## ADDENDUM NO. 2

**DATE:** October 8, 2019  
10/08/19

**PROJECT NO:** 190121

**RE:** AE Gage Center – Building A  
ADD-2, REV #2

**2 BUILDING A - SMALL FIN**  
SCALE: 1/2" = 1'-0"

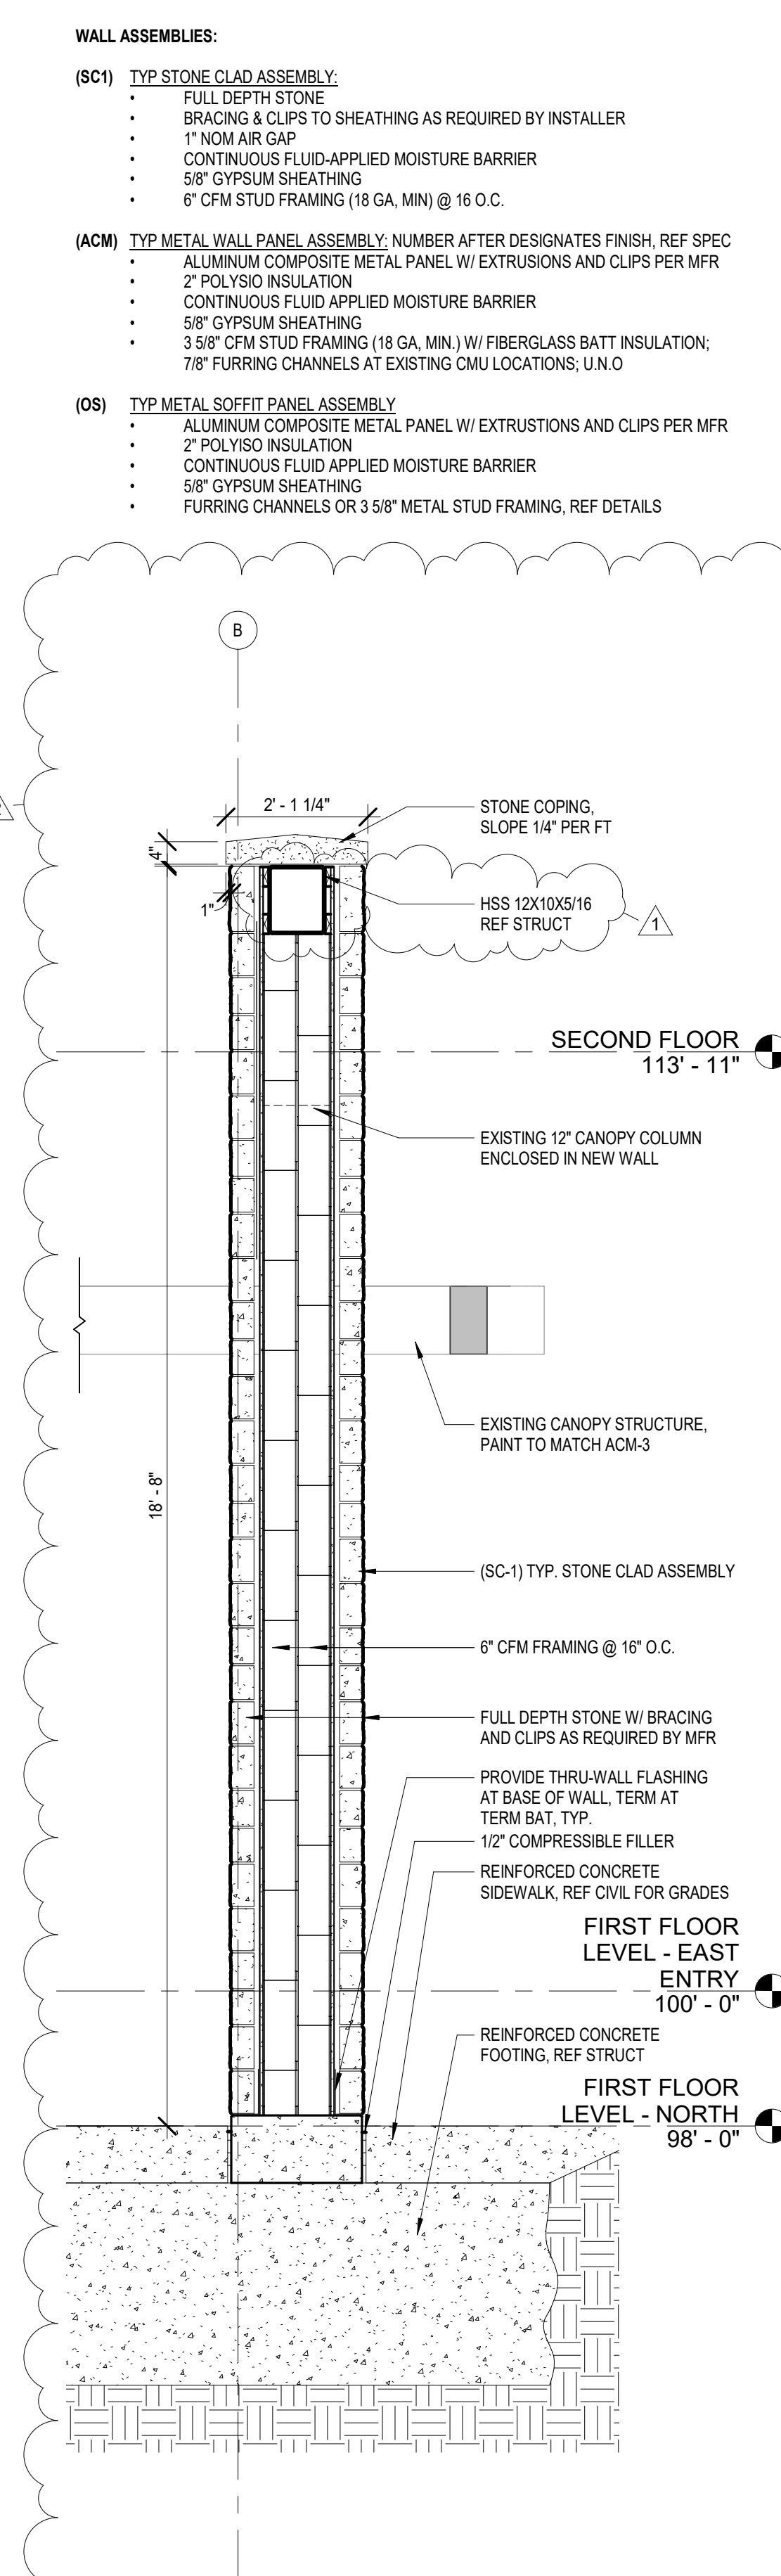
- A-6.B ADD detail C5/A-206 – Reception Desk – End Panel Detail
- A-7 Sheet A-301 – WALL SECTIONS – BUILDING A:
  - A-7.A 2/A-301 BUILDING A – SMALL FIN SECTION: Wall assembly shall be (SC-1) Typical Stone Clad Assembly: 4” Full depth stone, bracing and clips as required by installer, 1” NOM air gap, continuous fluid applied moisture barrier, 5/8” gyp sheathing, 6” CFM Stud framing (18 GA. Min.) at 16” O.C.

- A-7.B Stone coping shall be 2’- 1 ¼”
  - A-7.C Provide thru wall flashing at base of wall, term at term bar; typ.
- A-8 ADD Sheet A-304 – ENLARGED STAIR PLAN AND SECTION.
